Subject: First Review of Notice of Intention to Commence Large Mining Operations, Geneva Rock Products, Inc., Center Creek Quarry Mine, M/051/0013, Wasatch County, Utah

**FIRST REVIEW OF NOTICE OF INTENTION
TO COMMENCE LARGE MINING OPERATIONS**

**Geneva Rock Products, Inc.
Center Creek**

**M/051/0013
April 05, 2010**

Geneva Rock Products, Inc.
Center Creek DOGM NOI
Figure 10

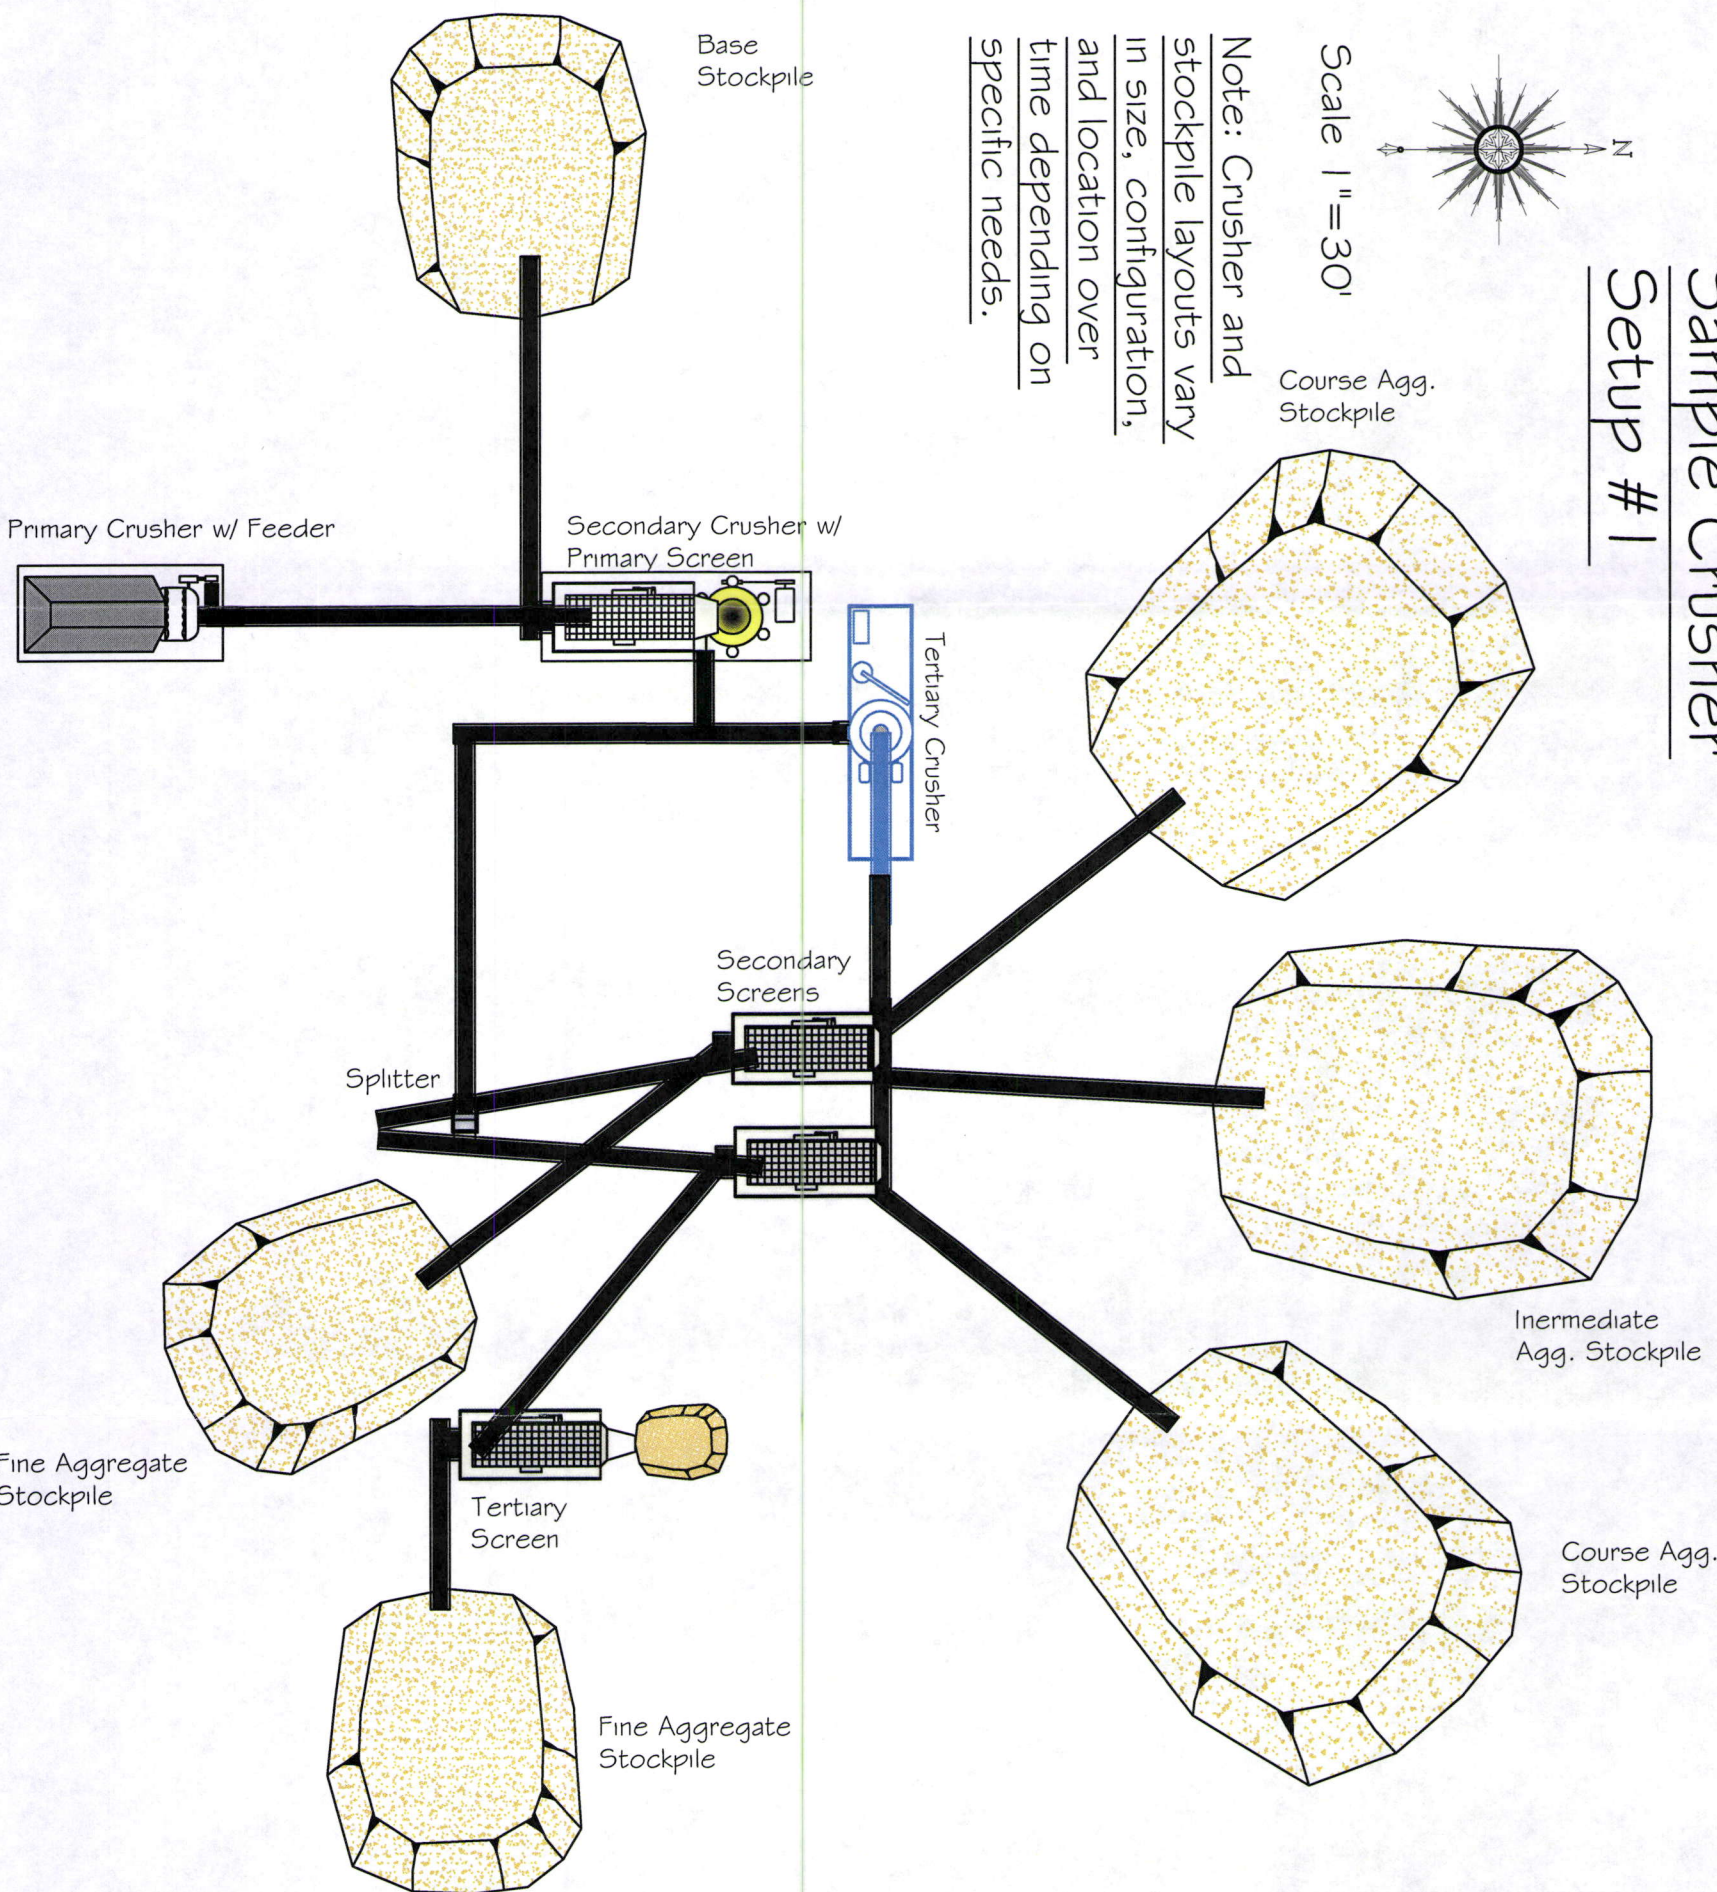
| Comm ent # | Sheet/Page/ Map/Table # | Comments | Initials | Review Action |
|---------------|-------------------------------|--|----------|------------------|
| ✓ 3 | Omission | No drawing is provided for the crushing, screening & processing. | lah | |
| ✓ 4 | Omission | No stockpiles are shown, yet written in text; could rewrite text. <i>crusher, stockpile area hatched</i> | lah | |

Note: Crusher and stockpile layouts vary in size, configuration, and location over time depending on specific needs.

TITLE: Center Creek Quarry
DOGM NOI
Figure 11

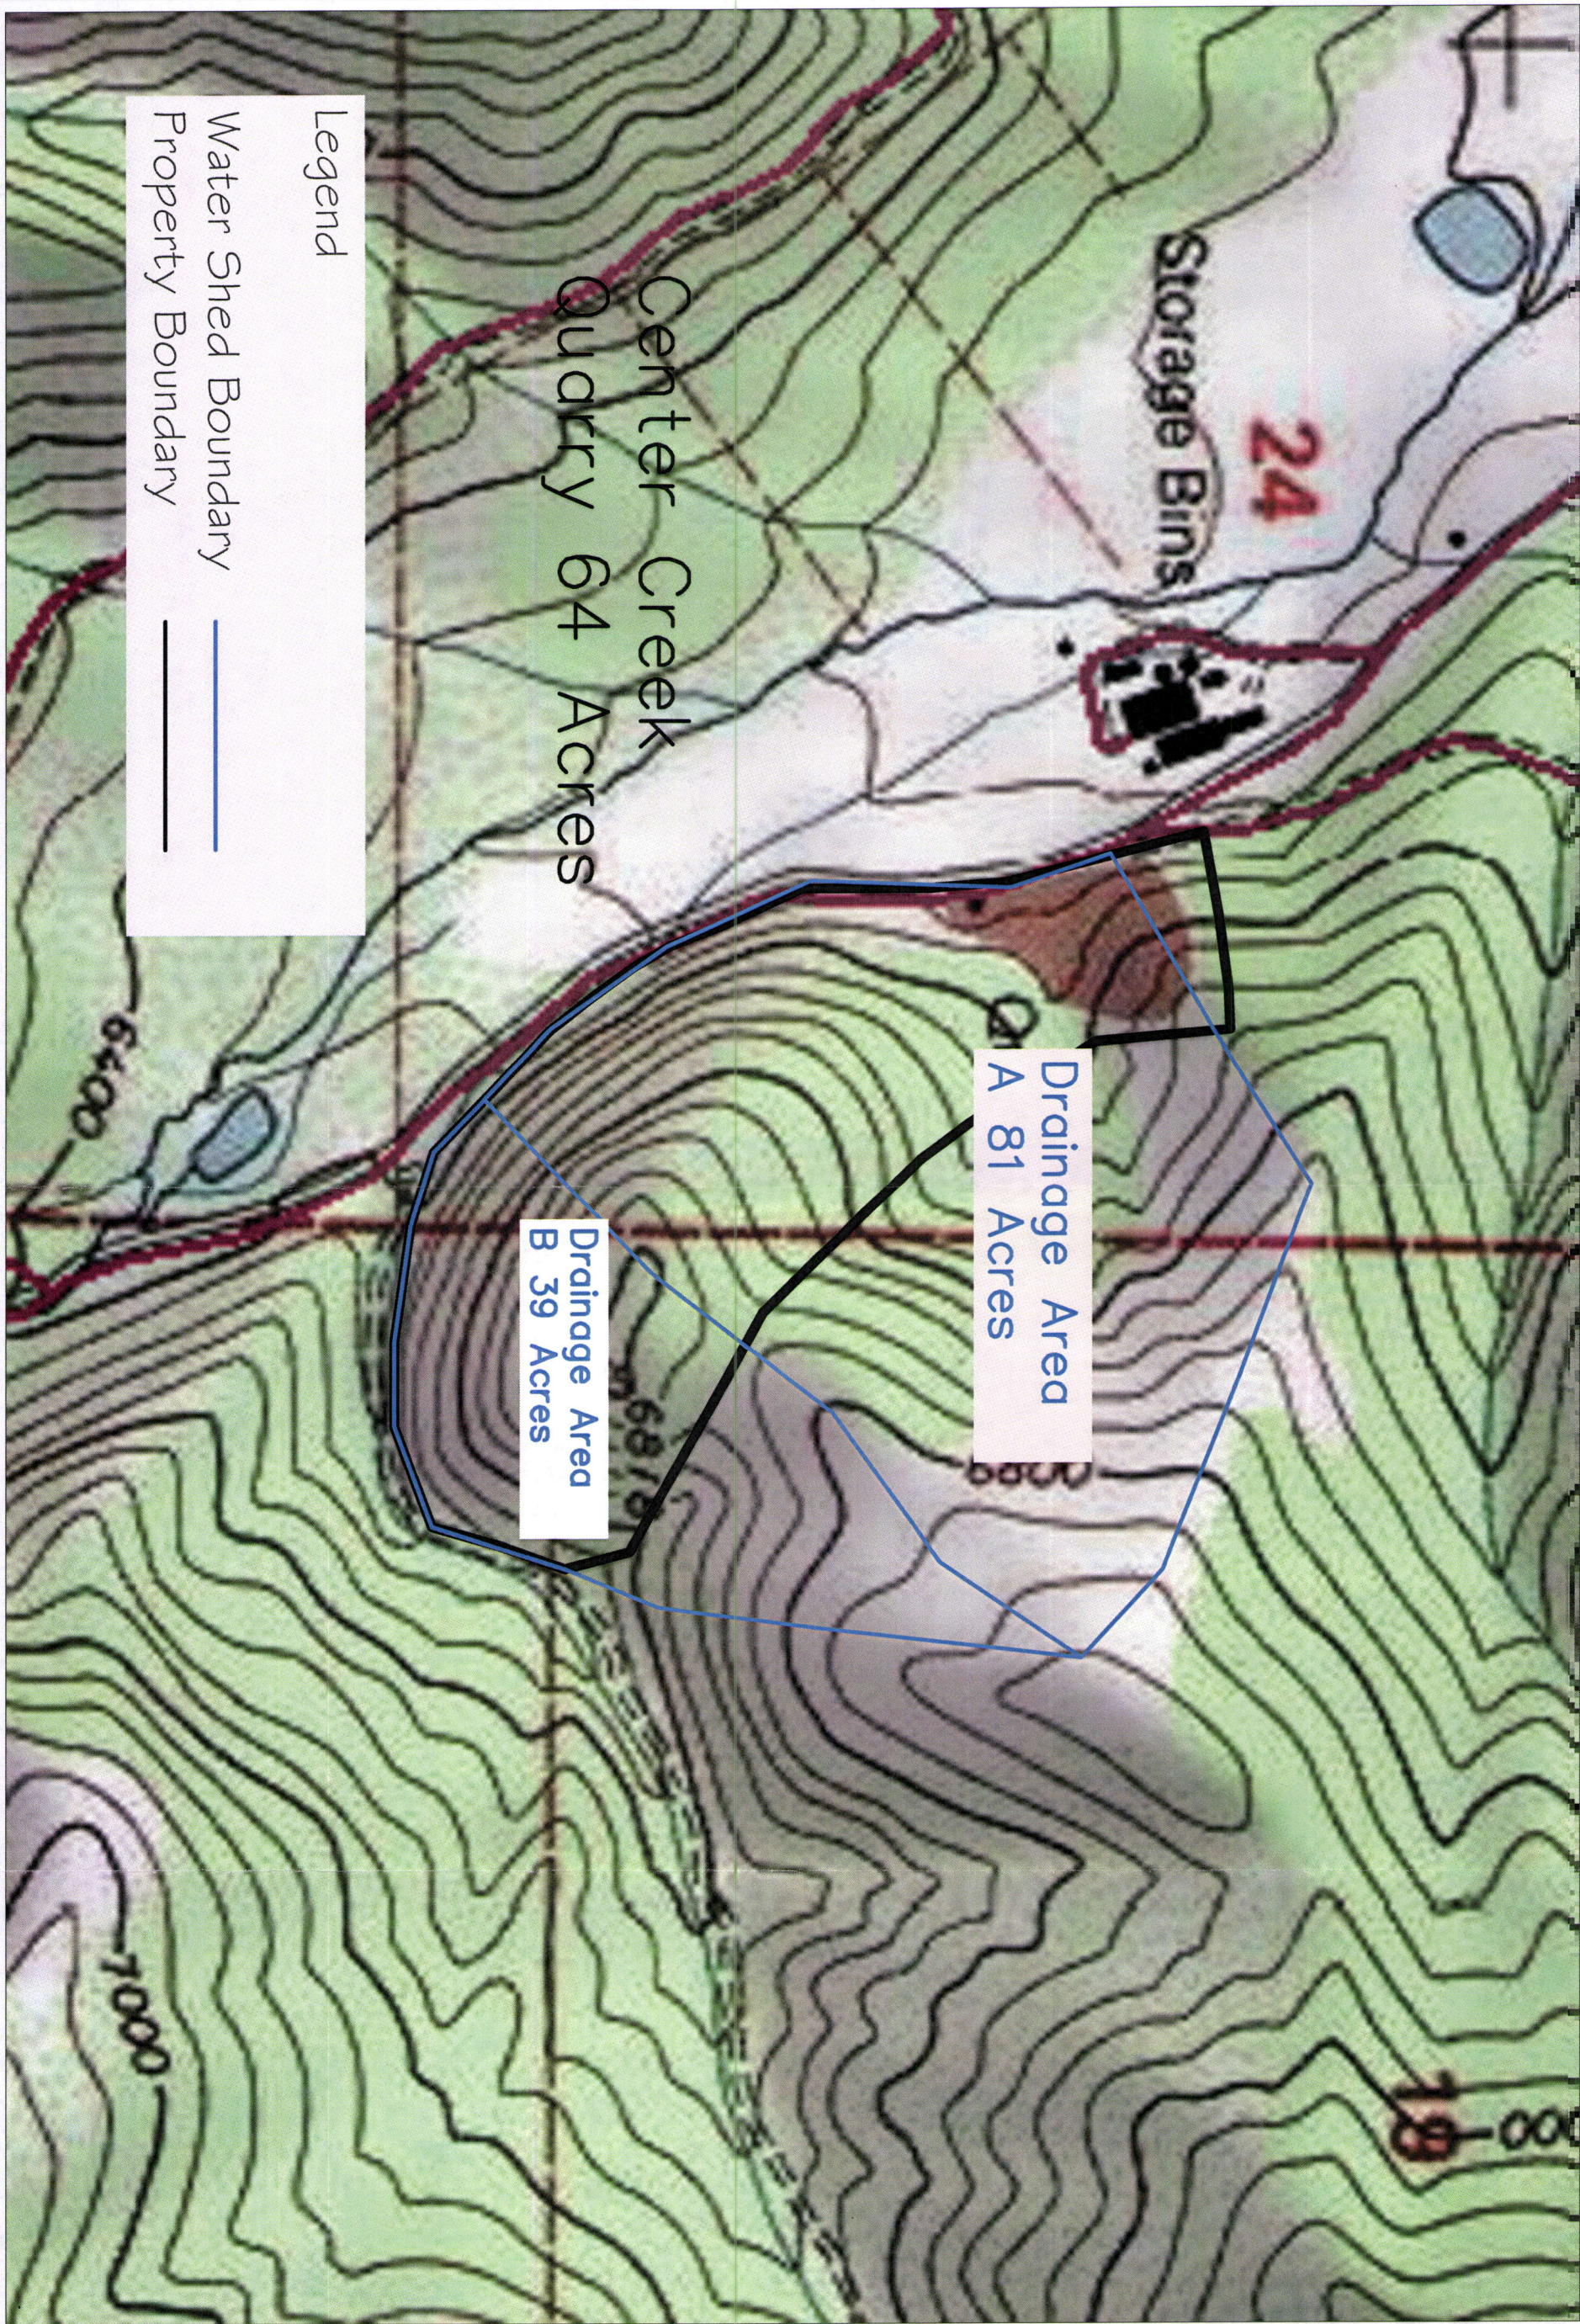
| Comment # | Sheet/Page/Map/Table # | Comments | Initials | Review Action |
|-----------|------------------------|---|----------|---------------|
| ✓ 10 | Omission | Watershed calculations were provided but no watershed map. Please provide a watershed map. | TM | |

SECTION Z - Z

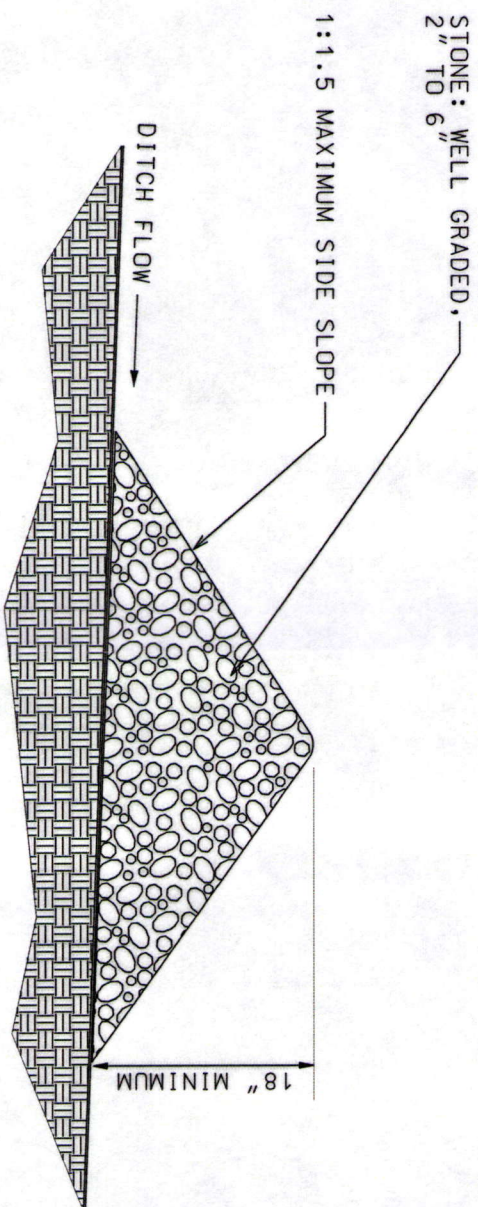
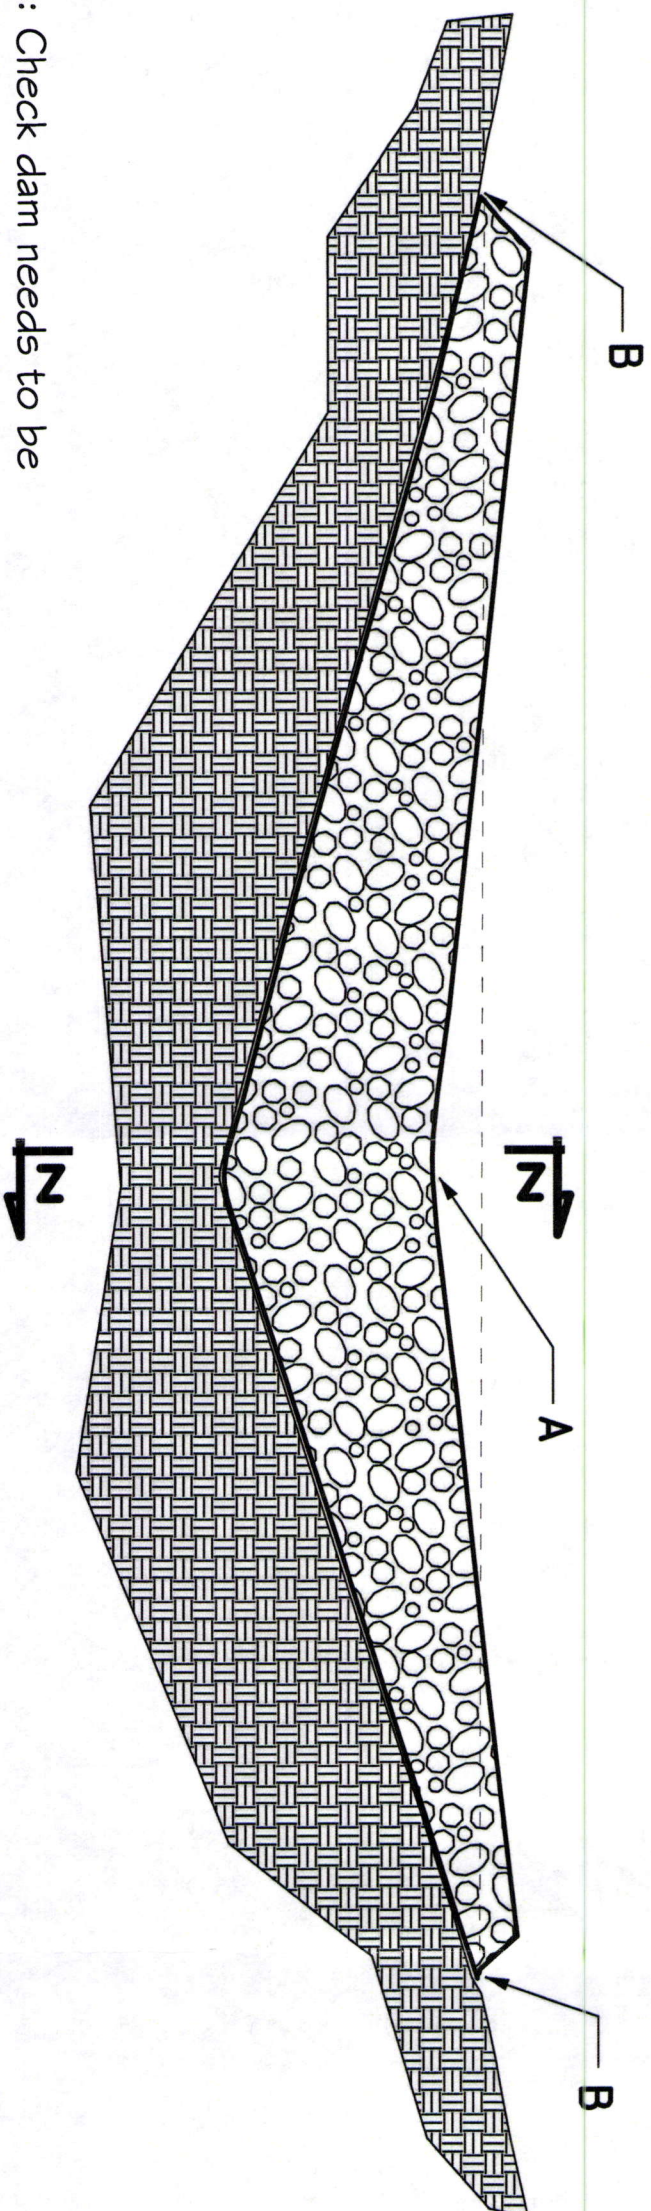
| Comment # | Sheet/Page/Map/Table # | Comments | Initials | Review Action |
|-----------|------------------------|---|----------|---------------|
| ✓ 11 | Check dam figure | Check dams need to be keyed in to the beds and banks when installed. Please add a note to the figure. | TM | |

Note: Check dam needs to be keyed into natural bank during installation.
